BLACK RIVER WILD FOREST

North Lake (J.P. Lewis) Tract Conservation Easement

Proposed Final Amendment

1996 Black River Wild Forest Unit Management Plan

Figure 1. Proposed Snowmobile Trail System and Periphery Areas for the Black River Wild Forest.

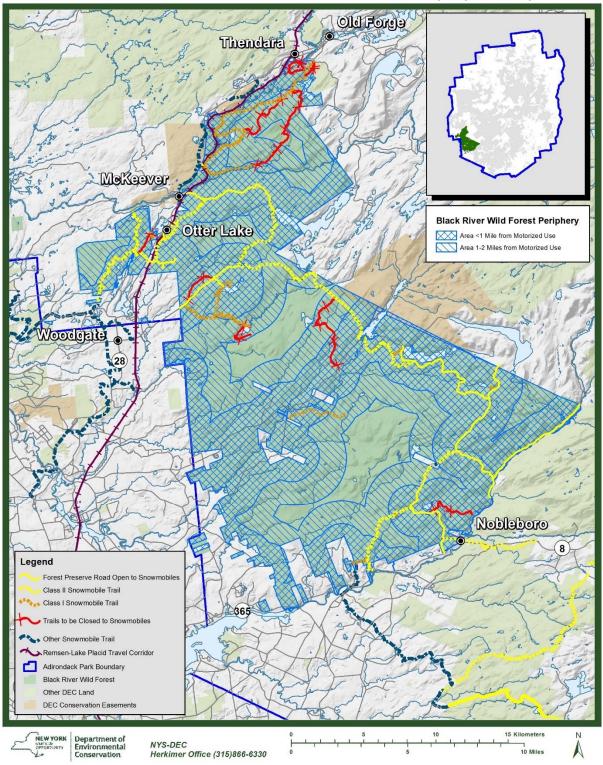
Comment: The snowmobile trail maps are confusing and do not provide enough detail.

Comment: The periphery buffer around the North Lake-Sand Lake-Mill Creek Trail depicted on the UMP Amendment map does not appear to follow the rules in the <u>Management Guidance</u>.

Response: The maps have been revised.

Response: The <u>Management Guidance</u> defines the "periphery" as the geographic area within two miles of a motorized travel corridor (non-snowmobile public motor vehicle routes and motorized waterbodies). Including Wolf Lake Landing Road to its end at Woodhull Lake, as well as motorized lakes, specifically Gull Lake and Woodhull Lake, in the area produces the periphery buffers depicted on the map included within the UMP Amendment. Furthermore, the <u>Management Guidance</u> states "A small number of existing DEC snowmobile trails in the Park shown to be located partly within remote interior areas may receive Class II designation due to their importance and may be retained and kept open, as long as either of the following conditions are met: 1) the remote interior area of concern is small-no more than 750 acres in area; or, 2) the trail segments of concern are located further than one-half mile into the interior from any

Figure 5. Proposed Snowmobile Trail System Between North Lake and South Lake.

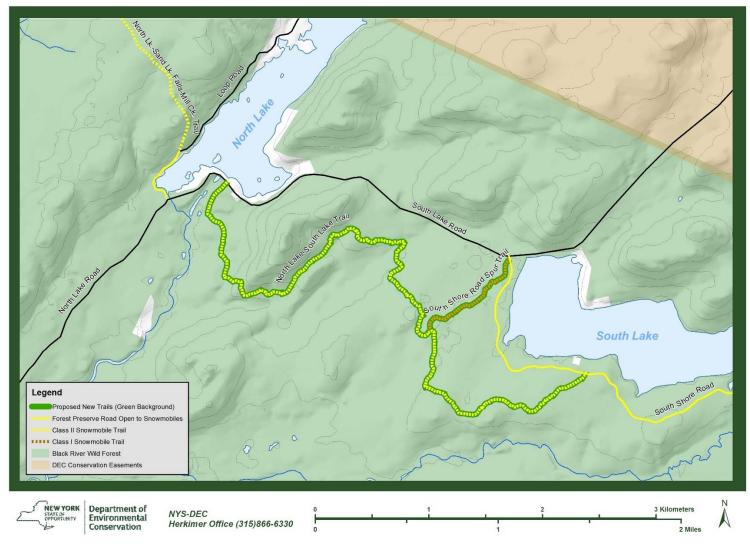
Comment: Build the proposed North Lake-South Lake Snowmobile Trail as a road.

Comment: Commenters question the funding and labor sources for constructing the North Lake-South Lake Trail.

Response: The APSLMP and DEC's "CP-38 Forest Preserve Roads Policy" both state that "no new roads or state truck trails can be constructed in Wild Forest areas unless such construction is authorized by Article XIV, Section 1 of the New York State Constitution and such construction is absolutely essential to the protection or administration of the area, no feasible alternative exists and no deterioration of the wild forest character or natural resource quality of the area will result. In addition, such construction is allowed only if it will not result in a material increase in the cumulative mileage of roads open to motorized use by the public in Adirondack Park Wild Forest units." This proposed trail cannot be built as a road without further approval and is being retained in the UMP Amendment as a snowmobile trail.

Response: Funding will likely come from a variety of sources including DEC budget appropriations. Labor for this project will likely come from a combination of sources including DEC staff and volunteers.

Figure 6. Proposed New Parking Lots at the Stone Dam Trailhead and North Lake.

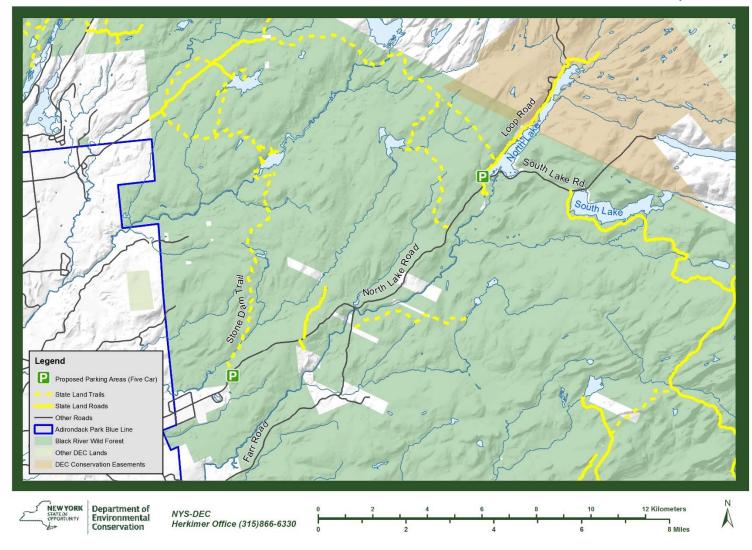
Comment: Additional parking areas should be installed along North Lake Road and South Lake Road.

Comment: The parking area at the Stone Dam Trailhead is inadequate; DEC should improve this parking area.

Response: The UMP Amendment includes a proposal for a new five car parking lot just off of North Lake Road (on Loop Road) at North Lake. A larger, improved parking lot (5 car) at the Stone Dam Trailhead has been added as well.

Response: The UMP Amendment has been revised to include parking at an improved 5 car parking lot at the Stone Dam Trailhead.

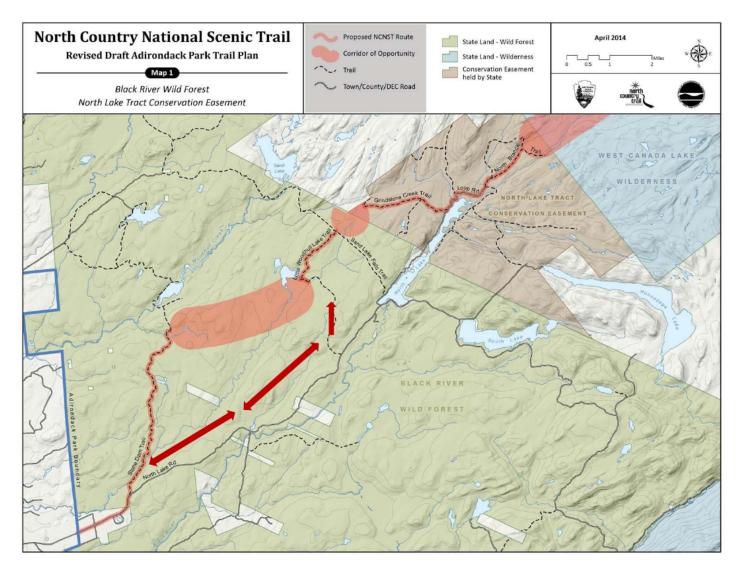
Comment: The level of detail provided concerning the NCNST route is unsatisfactory since the <u>North Country National Scenic Trail Adirondack Trail Plan/Final Generic</u> <u>Environmental Impact Statement</u> stated that the individual UMPs for each unit would address infrastructure needs such as designated campsites and bridges across streams.

Comment: Commenter states that changing the proposed route for the NCNST to be located further south of Little Woodhull Lake and closer to North Lake Road on the higher elevation hardwood ridges would result in a trail that is easier to construct and maintain with less environmental impact and higher aesthetic values.

Response: Comment noted. While still largely conceptual in nature, the proposed NCNST route has been revised to include greater detail concerning infrastructure needs. However, the exact route and required infrastructure such as bridges will not be

Response: Comment noted. The proposed, tentative route has been adjusted.
